REDUNDANCY CIRCUITRY

FOR ALL GENERAL ELEVATOR CORP. HARDWIRE RELAY SYSTEM.

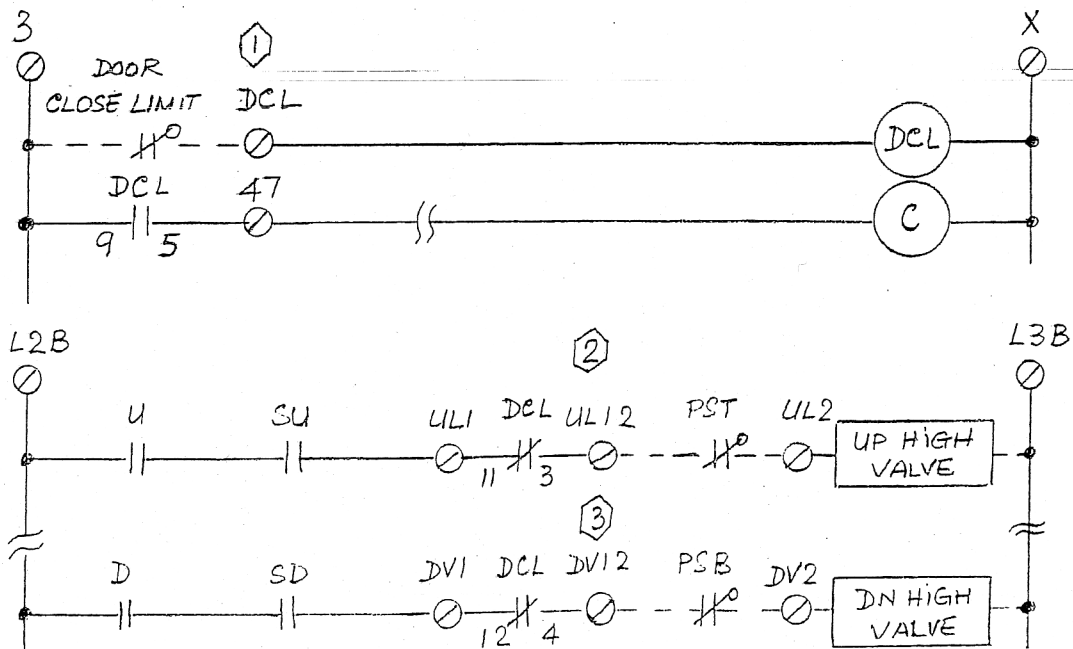
- ① REMOVE FIELD WIRE FROM TERMINAL 47 TO DCL AND INSTALL NEW RELAY AND CONTACT AS ABOVE.
- ② REMOVE THE TOP SLOW DOWN CONTACT FROM TERMINAL UL1 TO NEW TERMINAL UL12, AND INSTALL NEW DCL CONTACT AS ABOVE.
- ③ REMOVE THE BOTTOM SLOW DOWN CONTACT FROM TERMINAL DV1 TO NEW TERMINAL DV12, AND INSTALL NEW DCL CONTACT AS ABOVE.
